Your ref: SSD-10425
File no: MC-20-00005

**(SSD10425): Stage 2 – Detailed Development Application - Tallawong Station
Precinct South**

Blacktown City Council's submission to:

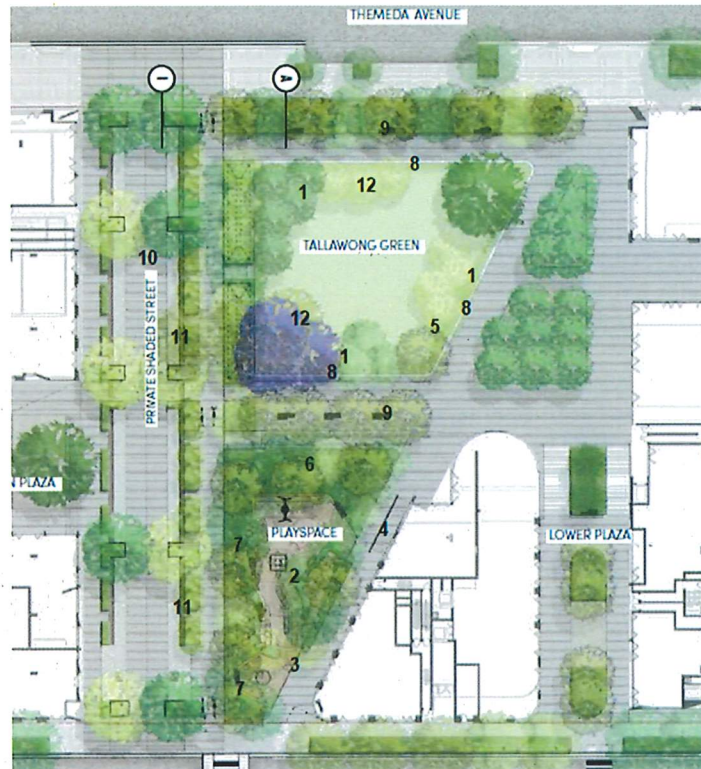
- Figure 18 of the Civil and Stormwater Report prepared by AECOM Project No 60618532, dated 07.05.2020 shows the regional bioretention basin with an existing filter area of 431 m² and the additional filter area highlighted but no size shown. The current MUSIC model (to be revised) shows a total required filter area of 734 m². This almost doubles the existing filter area, but the area shown on the plan appears out of scale or insufficient to achieve this

- the design appears to show the current basin expanding towards Cudgegong Road using retaining walls along the road boundary, but given its proximity to the intersection with Schofields Road it is unclear how this area can be safely and effectively maintained

- where access is available from only one side, a maximum filter width of 7.5 m is required. Where an access track is available on both sides, a maximum filter width of 15 m is required

- a more detailed investigation of the site for regional bioretention and in particular the services is required to demonstrate:
 1. what area is reasonable available and maintainable to the west of the current basin

2. whether the existing basin can be expanded to the east using part of the old road (services may be an issue), or
 3. whether the existing basin can be expanded to the south and reconstruct the current subsoil collection and overflow arrangements, or

4. can a splitter pit be provided downstream of the GPT and a portion of flow redirected around the existing basin to a new bioretention basin located downstream (possibly perched up) to operate independently of the existing basin, or

5. a combination of two or more of the above.
